Access Compliance Report

Public Rights-of-Way

Intersection ID: 17896	Main Street: BELROSE_LN	Cross Street: SCALEYBARK_RD	Location: NE
ADA ID: 560055C0A3C7	Ramp Type: Para	Initial Pass/Fail: Fail	Overall Compliance: No
Severity Score: 1.25			
Codes/Mitigation Info/Possible Solution		Field Measurements/Component Compliance

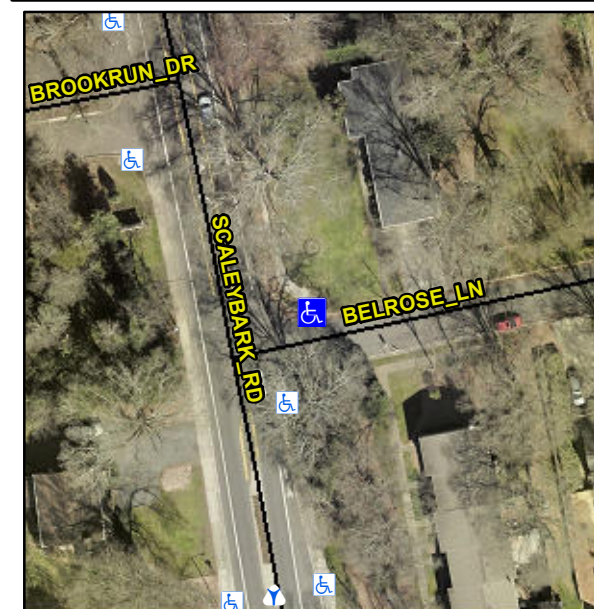
R304.5.3

Compliance	Description	Data	Compliance	Description	Data
N/A	Ramp Length LT (in)	53.0	N/A	Ramp Length RT (in)	N/A
Yes	Ramp Width LT (in)	67.0	N/A	Ramp Width RT (in)	N/A
Yes	Ramp Slope LT (%)	5.7	N/A	Ramp Slope RT (%)	N/A
No	Ramp XSlope LT (%)	2.8	N/A	Ramp XSlope RT (%)	N/A
N/A	Landing Length (in)	N/A	N/A	DWS Provided?	N/A
N/A	Landing Width (in)	N/A	N/A	DWS Contrast?	N/A
N/A	Landing Slope (%)	N/A	N/A	DWS Length (in)	N/A
N/A	Landing X Slope (%)	N/A	N/A	DWS Full Width?	N/A
N/A	Landing Curb? (Y/N)	N/A	N/A	DWS Offset (in)	N/A
N/A	Shared Landing?	N/A			
N/A	Gutter Ponding?	N/A	N/A	Gutter Slope (%)	N/A
N/A	Gutter Lip Ht (in)	N/A	N/A	Gutter X Slope (%)	N/A
N/A	Painted X Walk1?	No	N/A	Painted X Walk2?	N/A
	X Walk 1 Direction	To SW		X Walk 2 Direction	N/A
N/A	X Walk 1 Width (in)	N/A	N/A	X Walk 2 Width (in)	N/A
	X Walk 1 Slope (%)	3.8		X Walk 2 Slope (%)	N/A
	X Walk 1 X Slope (%)	1.8		X Walk 2 X Slope (%)	N/A
N/A	Ramp inside XWalk1?	N/A	N/A	Ramp inside XWalk2?	N/A

Remove & Replace Entire Ramp.
